UNITED STATES PATENT AND TRADEMARK OFFICE

APPLICATION NO.	FILING DATE	FIRST NAMED INVENTOR	ATTORNEY DOCKET NO.	CONFIRMATION NO.
10/605,036	09/03/2003	Masahiko Fukuda	SIC-03-032	2035
29863	7590	02/17/2006	EXAMINER	
DELAND LAW OFFICE P.O. BOX 69 KLAMATH RIVER, CA 96050-0069			CHARLES, MARCUS	
			ART UNIT	PAPER NUMBER
			3682

Office Action Summary	Application No. 10/605,036	Applicant(s) FUKUDA, MASAHIKO	
	Examiner Marcus Charles	Art Unit 3682

DETAILED ACTION

FIG. 1

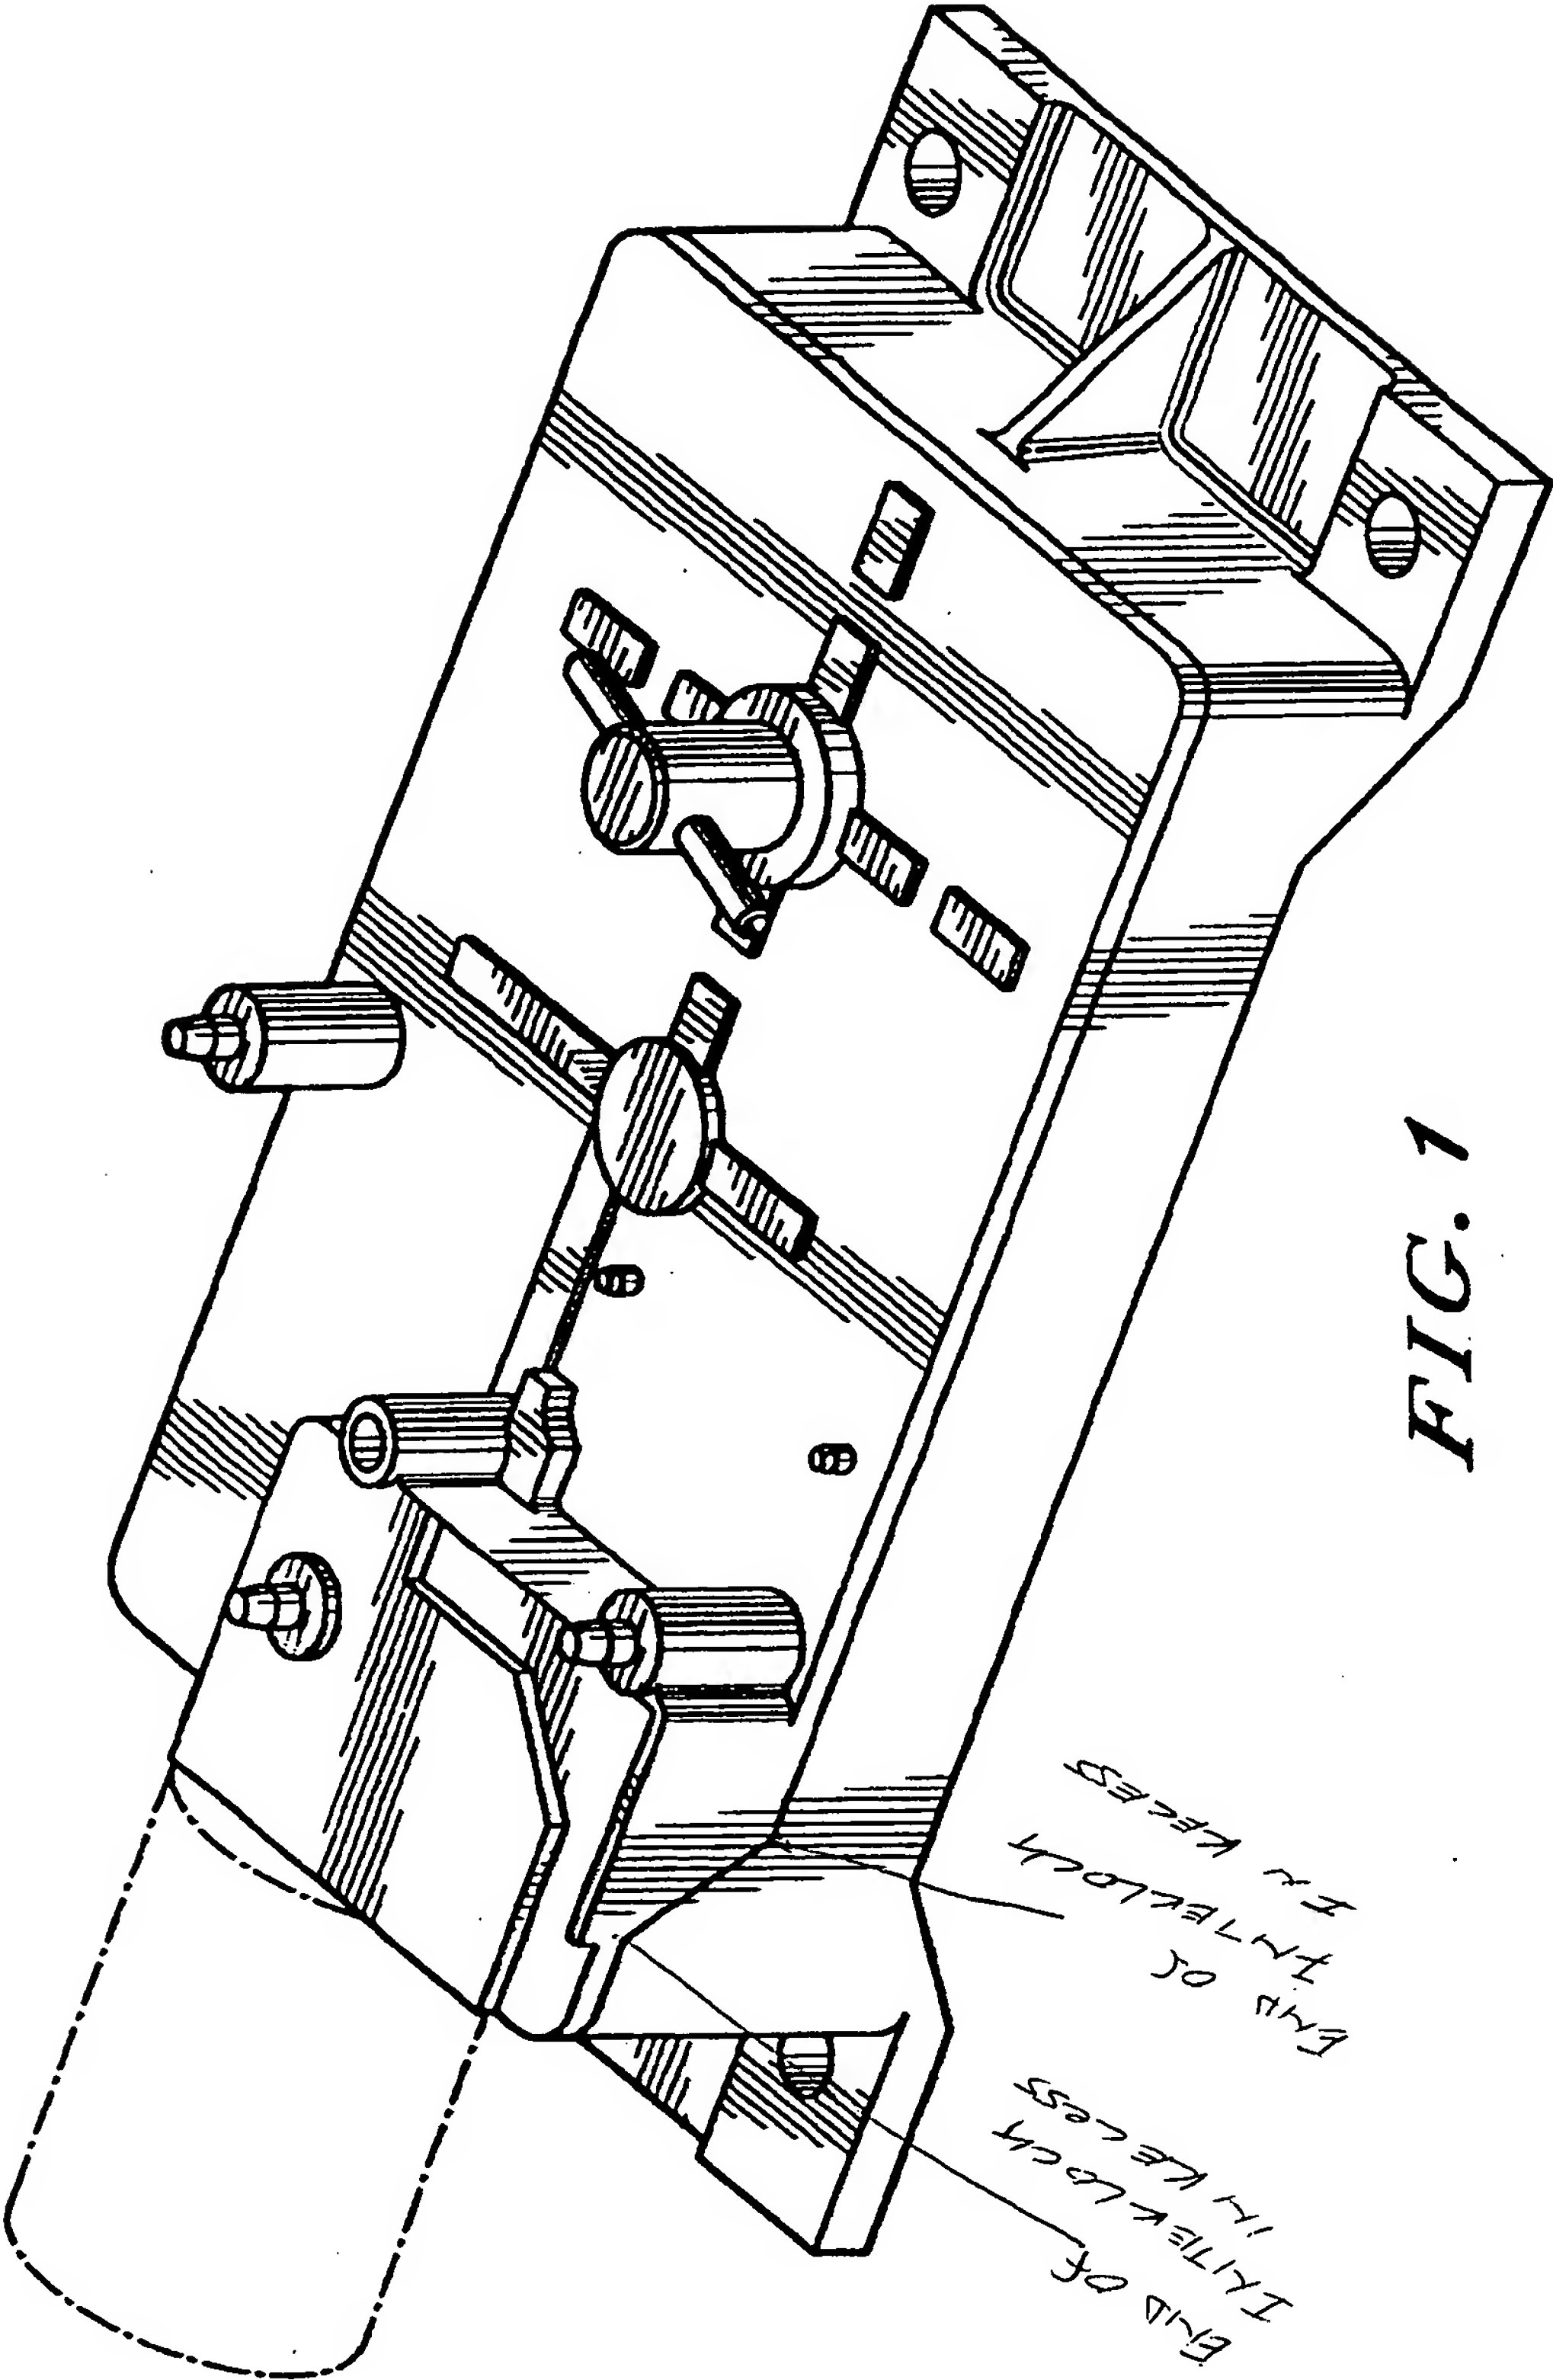
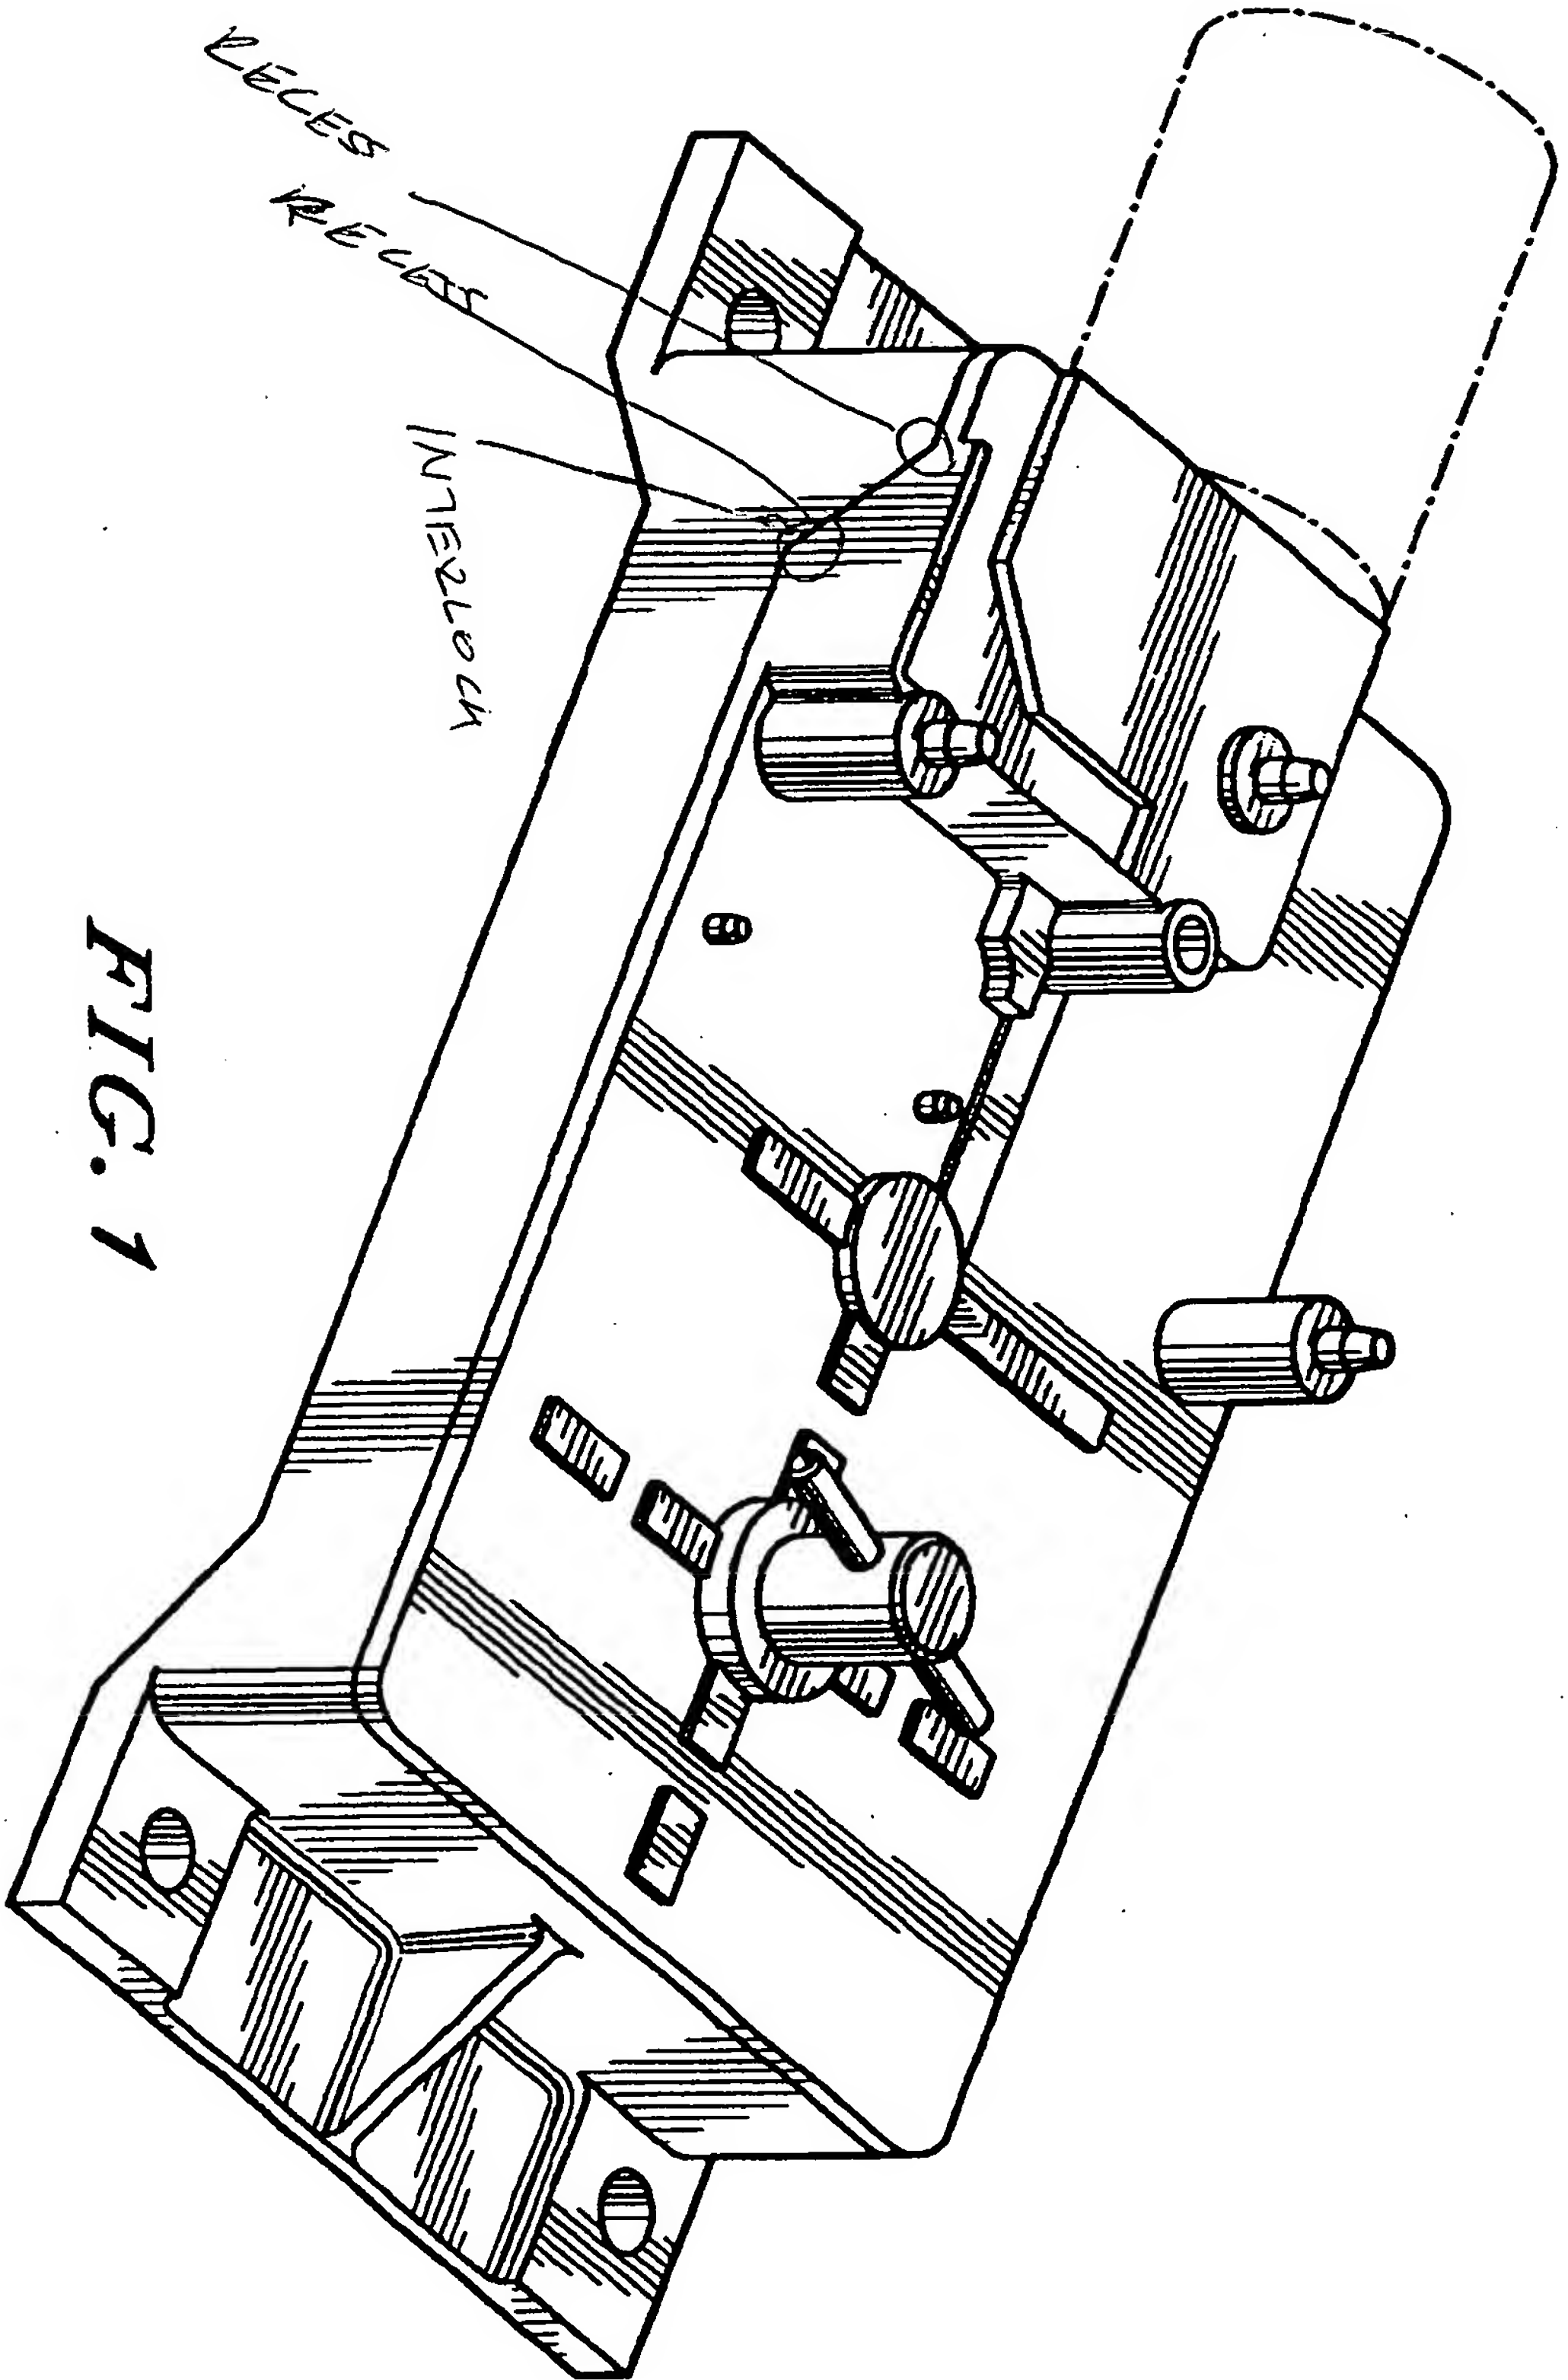
interlock the first and second base members. Kerdjoudj et al. disclose a housing having a misalignment mechanism comprising an interlock mechanism (not labeled, see attached drawing). Therefore, it would have been obvious to one of ordinary skill in the art at the time of the invention to modify the housing bases of EP (1010613) so that the alignment mechanism include interlocking features in view of Kerdjoudj et al. to make the connection easier and to ease the complexity of assembly.
